Addendum & Corrigendum No. 06 to General and Subsidiary Rule Book 2013 of S. E. C. Railway.

In the General & Subsidiary Rule Book- 2013,

(b) Type of whistle boards:-

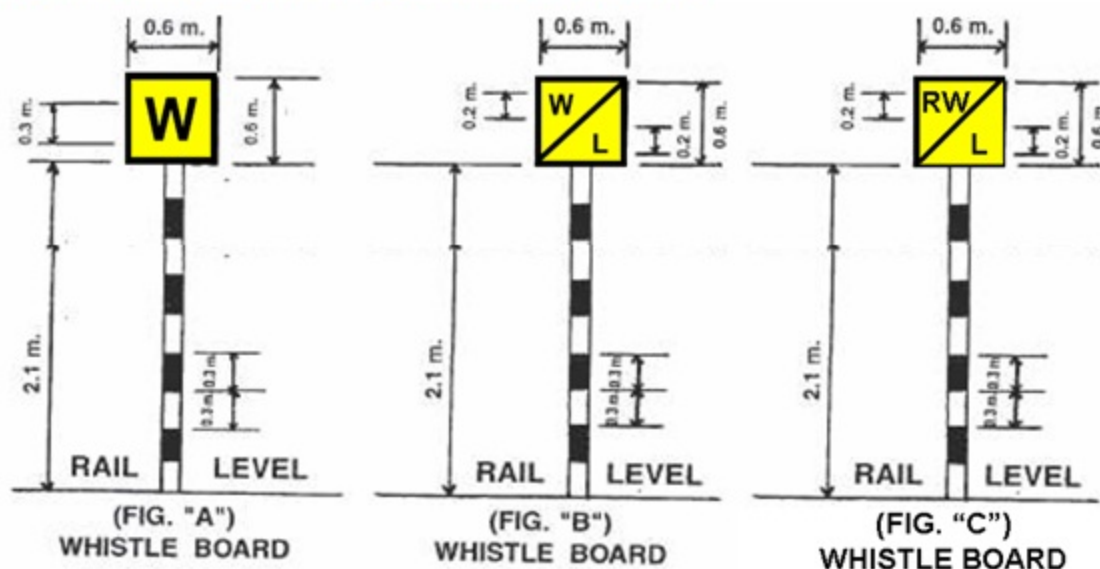
(3) The SR 4.50.02 (a) (b) (i) are revised as follows:-

(i) There are three types of whistle boards as follows:

(4) The following SR 4.50.02(ix) is revised as follows:-

Whistle boards as per fig (B) with the letters (W/L) 0.2m high, shall be provided on the approach to all unmanned 'C' class level crossings and also to manned level crossings where the view is not clear on either side for a distance of 600 metres and those which have normal position open to road traffic, without interlocking and protection by signals, under special condition. The whistle boards should be bilingual as contained in Annexure-9/5 to Indian Railways Permanent way manual and be erected along the track and at a distance of 600 metres from level crossing, except where higher distance is otherwise directed under special circumstances.

The whistle board of as per figure (C) with the letters (RW/L) 0.2m high shall be provided on the approach to all manned & unmanned level crossings at a distance of 250m from LC gates in bilingual.
